Amendment Report

Application for Works Approval Amendment

Works Approval Number W6515/2021/1

Premises Waitsia Gas Project Stage 2

Figure 1: Predicted nighttime noise levels showing the location of modelled receptors (Source: ARC 2024).

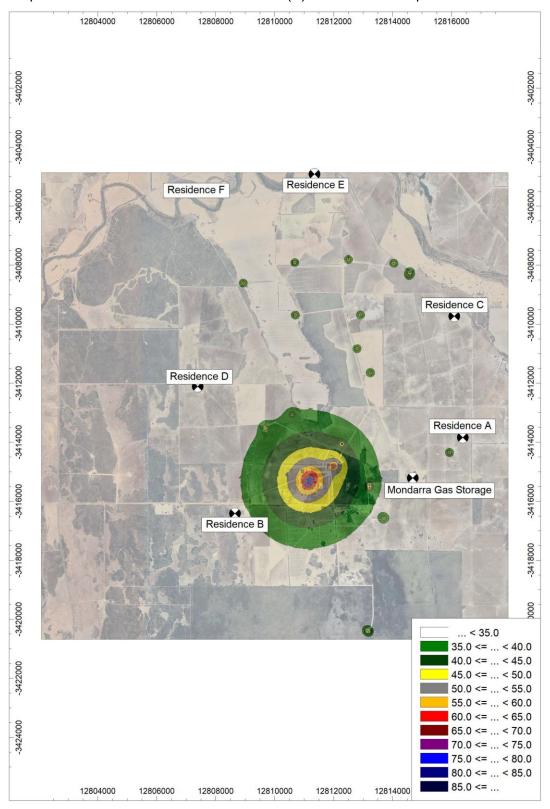
Results of modelling indicate that, under normal operating conditions, noise from the premises including the proposed debottlenecking (i.e. at a throughput of 100.375 PJ/year) is predicted to comply with the nighttime assigned noise level of 35dB(A) at all neighbouring residences. The highest predicted level at nearby residences was predicted to be 32.7 dB(A) at Residence B, located 2.5km southwest of the premises (Figure 1).

Notwithstanding this assessment, further consideration of cumulative noise emissions is necessary to confirm compliance with the Noise Regulations. As per the Noise Regulations, a noise emission must not cause, or significantly contribute to a level of noise which exceeds the assigned level at the nearest receptor. A noise emission is considered to significantly contribute to a level of noise if it exceeds a level 5 dB below the assigned level (i.e. 30dB(A) in this case).

As the predicted noise level is below 35 dB(A) but within 5 dB(A) of the prescribed standard, it is necessary to consider contributions from other noise sources to determine compliance. If ambient noise at the receptor identifies contributions from other industrial sources, the applicable nighttime assigned level is reduced to 30 dB(A), requiring further noise mitigation to achieve compliance. While the noise modelling considers emissions from both Stage 1 and Stage 2 premises, it does not consider noise emissions from other industrial noise sources.

The delegated officer acknowledges the potential for cumulative noise impacts but notes a degree of uncertainty regarding the contribution of external industrial sources and the relevant assigned noise levels. Given that ambient noise monitoring is unlikely to reliably capture the influence of nearby industrial premises, a precautionary approach has been applied requiring the premises to meet a noise level of 30 dB(A) at sensitive receptors.
